SNARL Classroom/Lecture Hall

FM140248L/981800

**Addendum No. 1**

April 3, 2014

C1.0

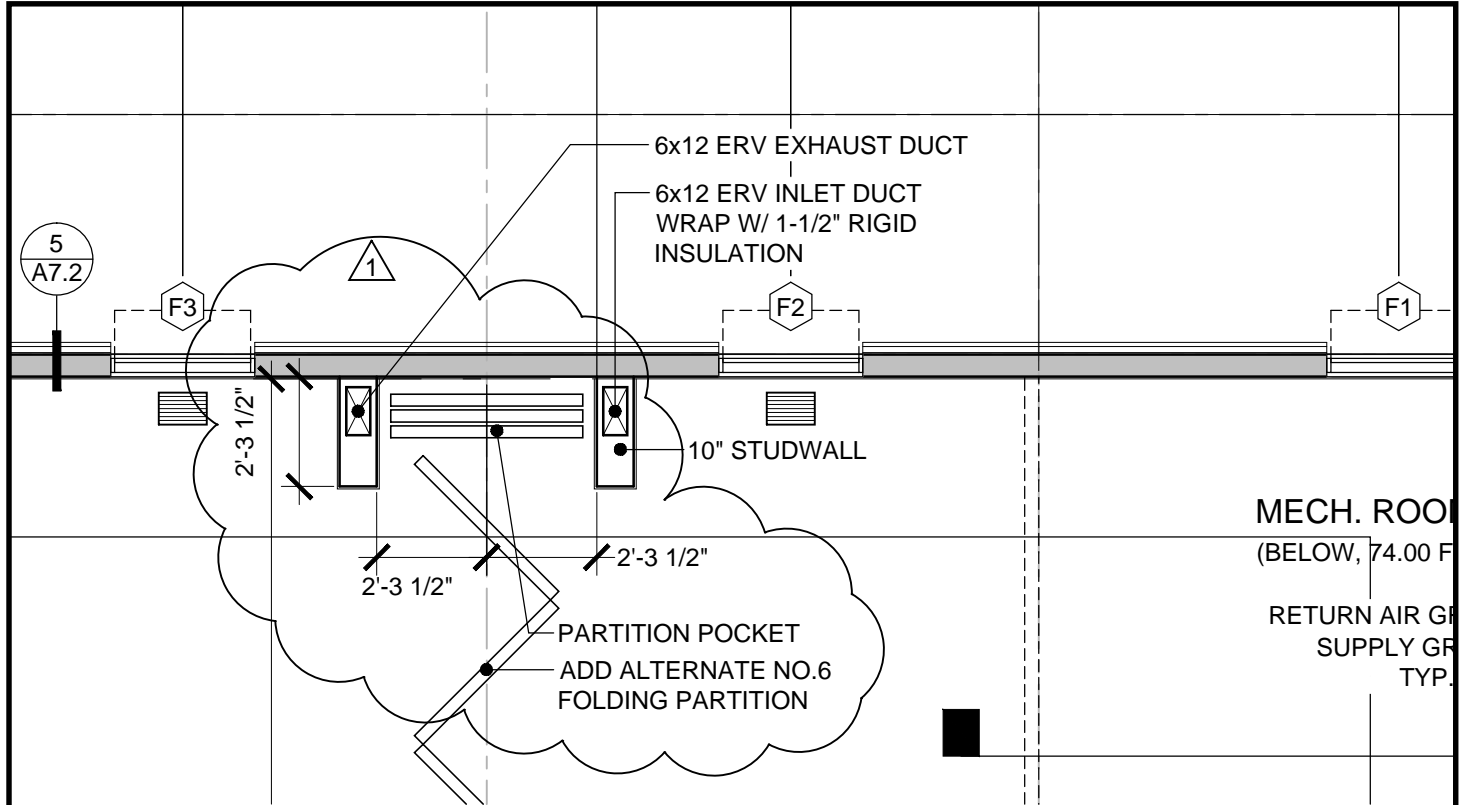
- 2-1. MODIFY Sheet C1.0, CONSTRUCTION NOTES, as described in the attached Exhibit A (See Page 1).
- 2-2 MODIFY Sheet A2.1, PARTITION POCKET, FLOORING LAYOUT, as described in the attached Exhibit A (See Page 2).

- ① INSTALL 3" AC PAVEMENT ON 5" AGGREGATE BASE.
- ② TRANSFER EXISTING BRASS CAP MONUMENT ELEVATION TO NEW CONSTRUCTION BENCHMARK IN PROTECTED LOCATION. SALVAGE MONUMENT TO OWNER.

- ③ CONSTRUCT 3" DEEP X 3' WIDE GRADED SWALE.
- ④ PAINT 2 COATS OF 4" WIDE WHITE PARKING STRIPES. MATERIAL AND APPLICATION SHALL BE IN CONFORMANCE WITH THE PROVISIONS OF SECTION 84, "TRAFFIC STRIPES AND PAVEMENT MARKINGS", OF THE CSS. REFER TO A1.0 SITEPLAN FOR DIMENSIONED LAYOUT.

- ⑤ RELOCATE EXISTING WATER VALVE AS SHOWN ON PLANS. PROVIDE RISER AND TRAFFIC RATED COVER FLUSHED WITH FINISHED AC PAVEMENT PER DETAIL THIS SHEET. DEEPEN EX. WATER LATERAL TO A MIN. DEPTH OF 42" OF COVER.

- ⑥ CONSTRUCT BOULDER GRAVITY RETAINING WALL, SEE DETAIL 6/A7.1.
- ⑦ SAWCUT AND REMOVE EXISTING AC PAVEMENT.
- ⑧ COVER EXISTING PARKING STRIPES IN CONFLICT WITH NEW LAYOUT WITH 2 COATS OF BLACK PAINT.

- ⑨ CONSTRUCT 1' WIDE SHOULDER PER DETAIL THIS SHEET.
- ⑩ INSTALL 3" DEEP X3' WIDE ROCK COBBLE SWALE PER DETAIL HEREON.
- ⑪ INSTALL ROCK COBBLE PATIO EDGING PER A1.0 SITE PLAN AND DETAIL 13/A7.1

- ⑫ INSTALL 750 NORWESCO SEPTIC TANK OR MONO COUNTY ENVIRONMENTAL HEALTH APPROVED EQUAL.
- ⑬ INSTALL 3 - OUTLET DISTRIBUTION BOX.
- ⑭ INSTALL 3-40' LONG X 3' WIDE LEACH TRENCHES PER MONO COUNTY ENVIRONMENTAL HEALTH REQUIREMENTS AND DETAIL THIS SHEET.

# NORTH INT. ELEVATION - LECTURE HALL

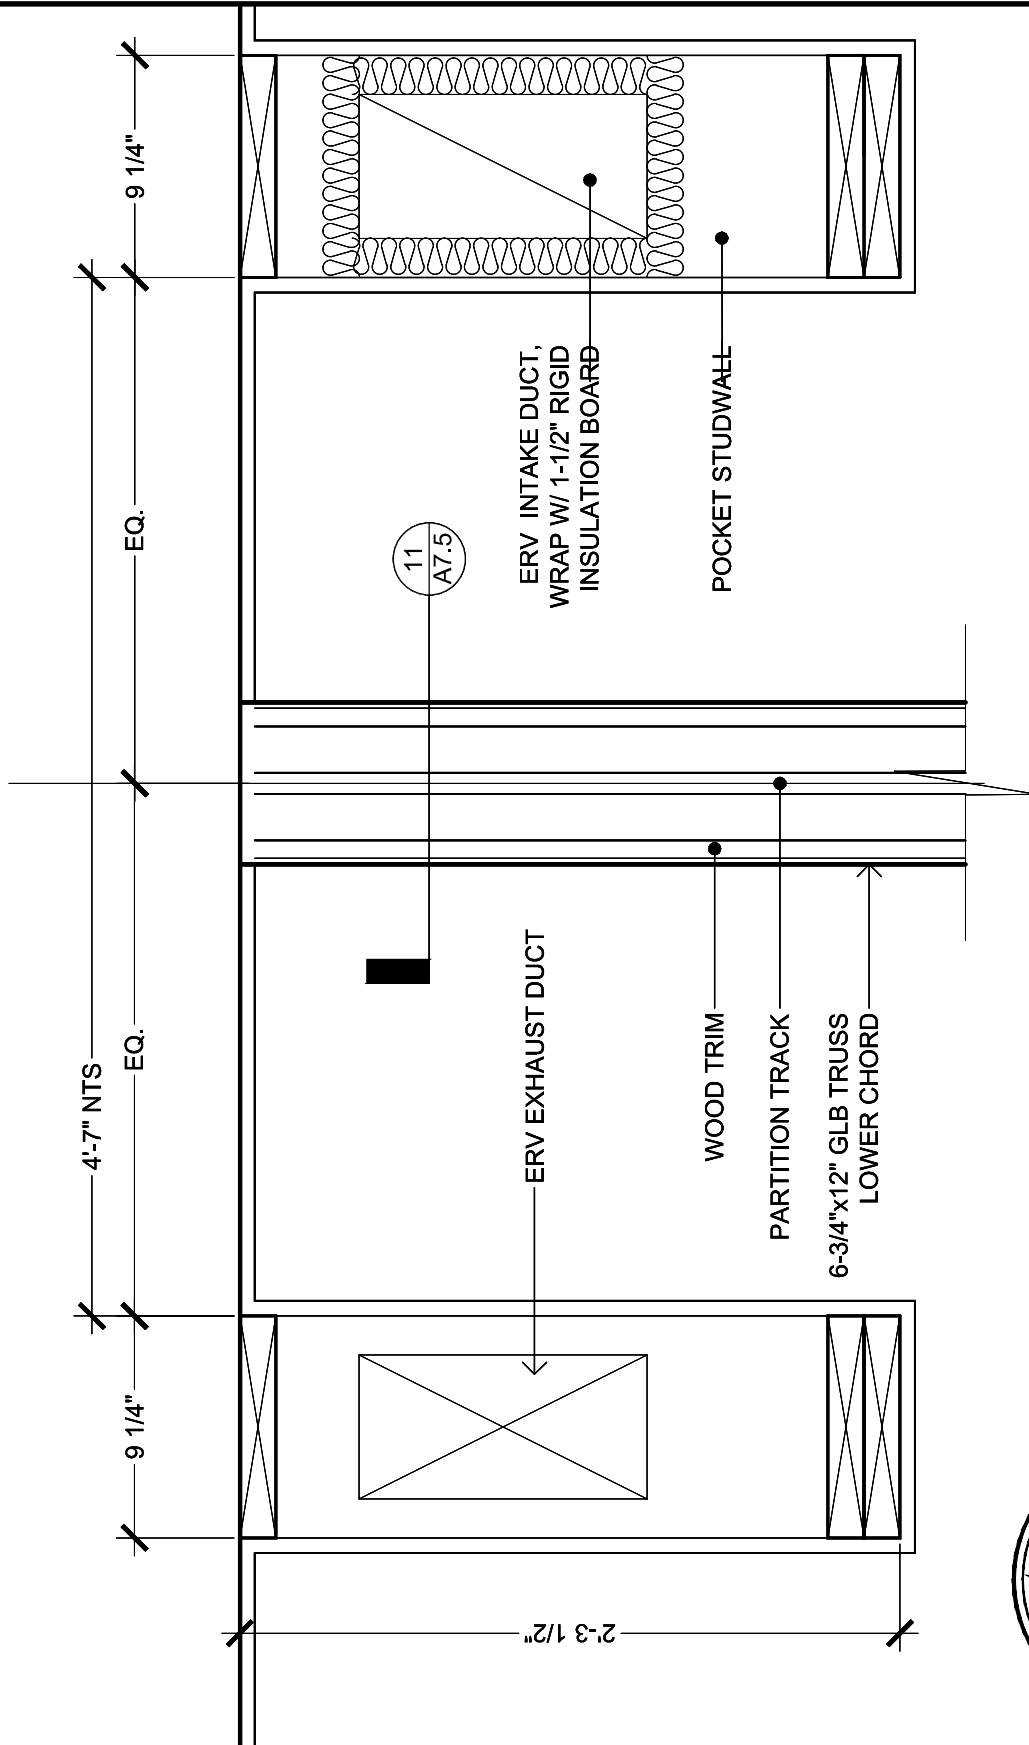
- 2-3 MODIFY Sheet A5.1, NORTH INT. ELEVATION – LECTURE HALL, as described in the attached Exhibit A (See Page 3).
- 2-4 MODIFY Sheet A7.5, PARTITION TRACK SUPPORT PLAN, as described in the attached Exhibit A (See Page 4).

# PARTITION TRACK SUPPORT PLAN

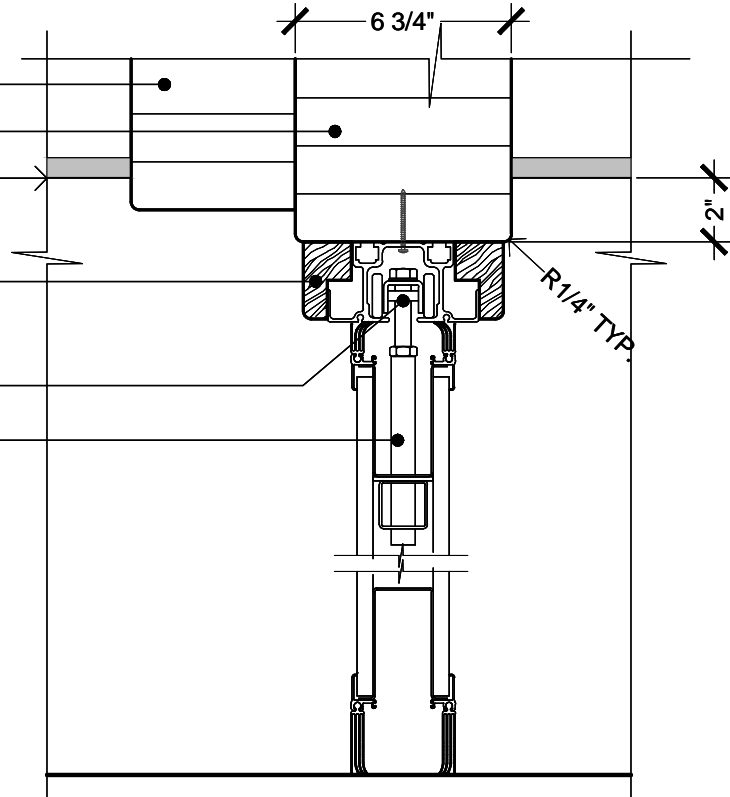
TRUSS BEAM  
TRUSS BOTTOM CHORD  
LINE OF CEILING @ POCKET

WOOD TRIM  
PARTITION TRACK,  
SCREW ATTACHMENT PER  
MANUFACTURER.

## PARTITION TRACK - ALT.6

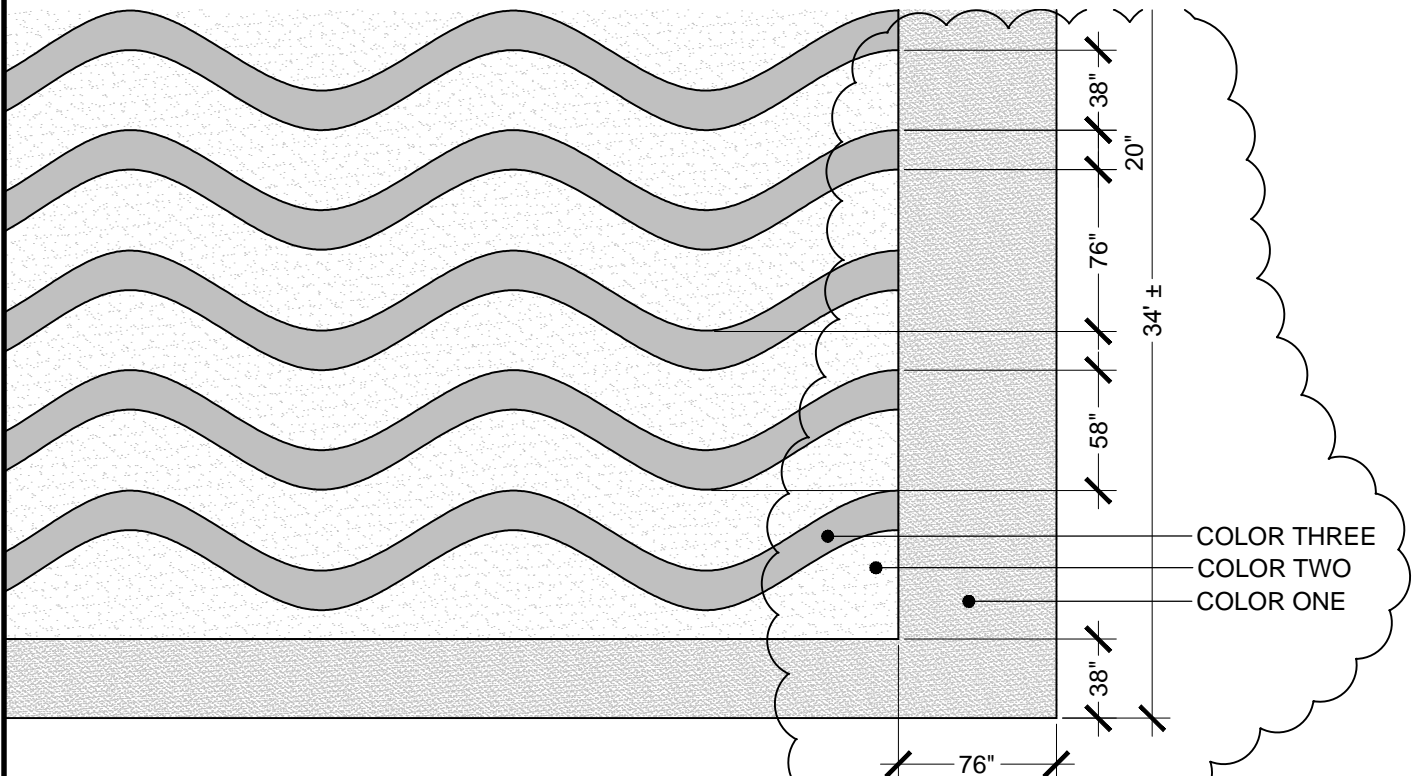
- 2-5 MODIFY Sheet A7.5, PARTITION TRACK – ALT.6, FLOORING PATTERN – ALT.4, as described in the attached Exhibit A (See Page 5).
- 2-6 MODIFY Sheet A8.3, SPECIFICATIONS - 10.00 SPECIALTIES, 12.20 WINDOW TREATMENTS, 13.650 PHOTOVOLTAIC SYSTEM, as described in the attached Exhibit A (See Page 6).

REFERENCE SHEET S1.1 [REVISION NO. 1]

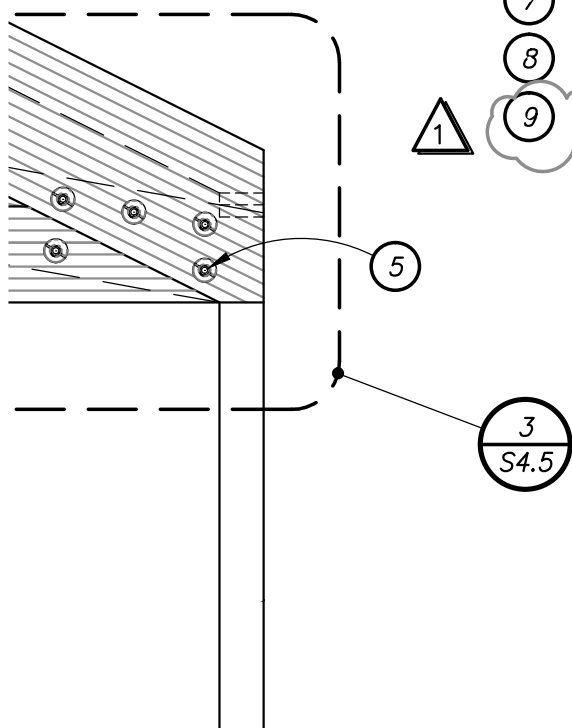
- 2-9**                    **MODIFY** Sheet S1.1, **FOUNDATION PLAN KEYED NOTES**, as described in the attached Exhibit A (See Page 9).
- 2-10**                    **MODIFY** Sheet S3.1, **TRUSS ELEVATION KEYED NOTES**, as described in the attached Exhibit A (See Page 10).
- 2-11**                    **MODIFY** Sheet S4.5, **DETAIL 5**, as described in the attached Exhibit A (See Page 11).

- ① 4x6 POST/TRIMMER FOR ROOF BEAM/HEADER ABOVE ~ WHERE POST OCCURS IN SHEAR WALL PROVIDE SHEAR WALL E.N. TO POST
- ② 6x6 POST/TRIMMER FOR ROOF BEAM/HEADER ABOVE ~ WHERE POST OCCURS IN SHEAR WALL PROVIDE SHEAR WALL E.N. TO POST
- ③ WHERE STUD LENGTH EXCEEDS 16'-0" PROVIDE DOUBLE STUD @ 16" O.C. SISTERED TOGETHER w/ 16d's @ 12" O.C. STAGGERED
- ④ STEP FOOTING DOWN AS REQUIRED TO MEET BASEMENT FOOTING. REFER TO DETAIL 12/SO.3 FOR CONSTRUCTION REQUIREMENTS
- ⑤ SQUARE PAD FOOTING
- ⑥ PROVIDE HOLDOWN CONNECTION THROUGH FLOOR PER DETAIL 9/SO.3
- ⑦ PROVIDE 4'-0" WIDE CRAWL SPACE ACCESS UNDER DOOF WAY. HEAD OUT OPENING w/ 6x6 HEADER
- ⑧ FLOOR HATCH OR VENT OPENING PER ARCH'L. ~ HEAD OUT PER DETAIL 3/SO.5 WHERE A JOIST NEEDS TO BE CUT.
- ⑨ 4" CONCRETE SLAB-ON-GRADE AT BASEMENT FLOOR BELOW.
- ⑩ 6x8 POST FOR ROOF TRUSS ABOVE ~ WHERE POST OCCURS IN SHEAR WALL PROVIDE SHEAR WALL E.N. TO POST

REFERENCE SHEET S4.5 [REVISION NO. 1]

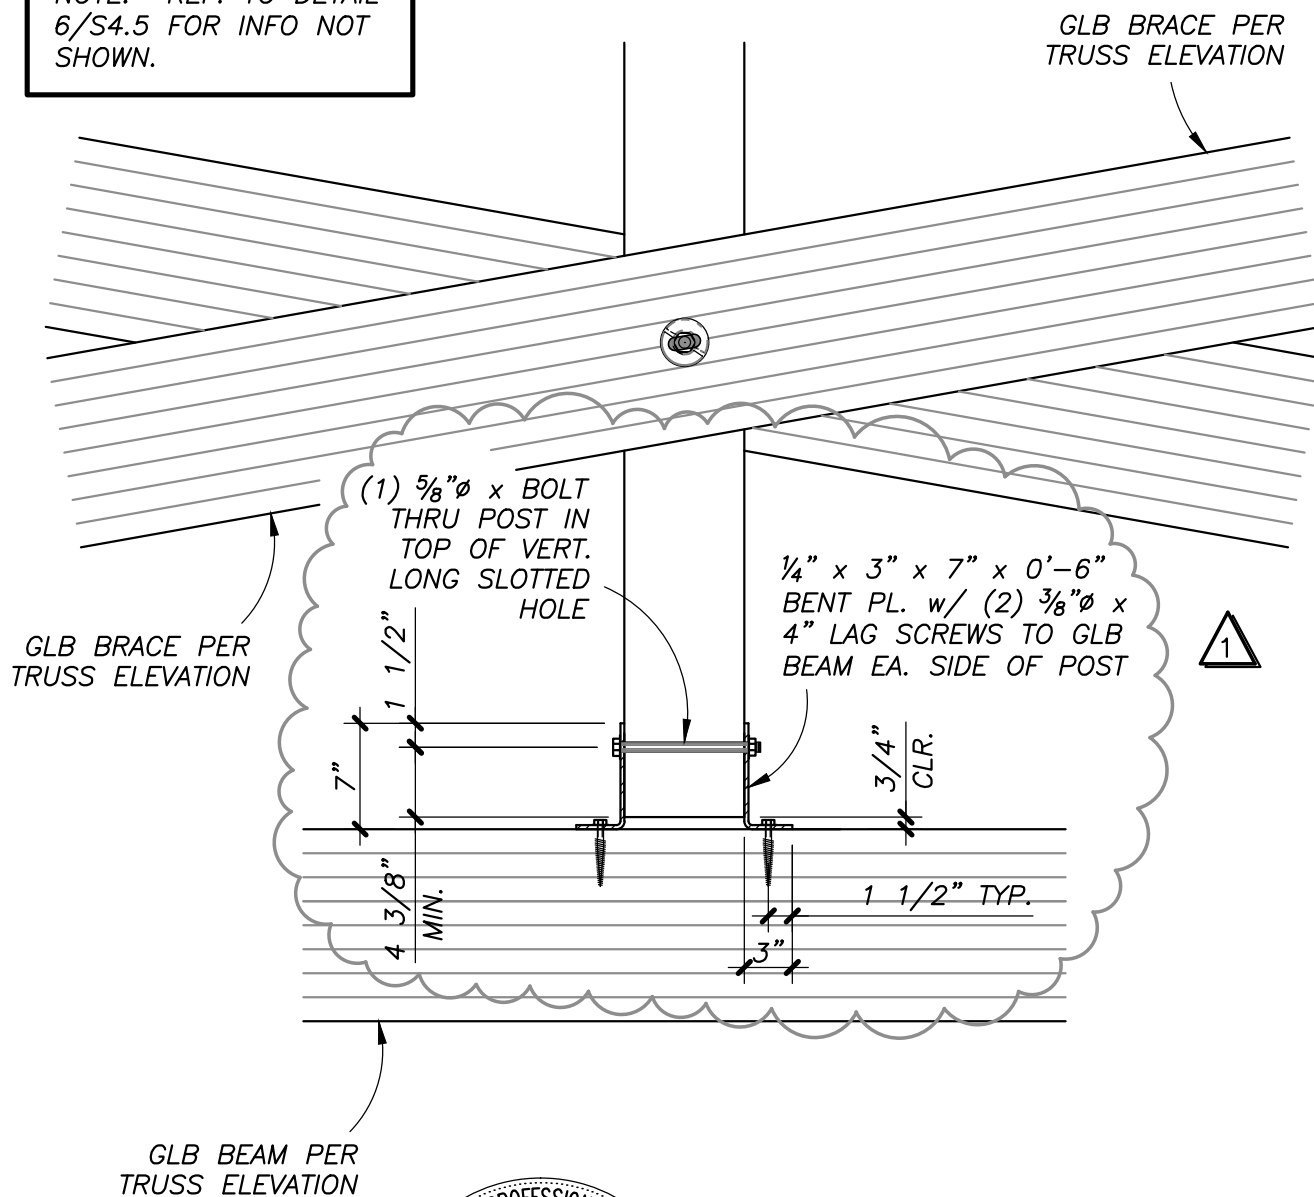
NOTE: REF. TO DETAIL  
6/S4.5 FOR INFO NOT  
SHOWN.
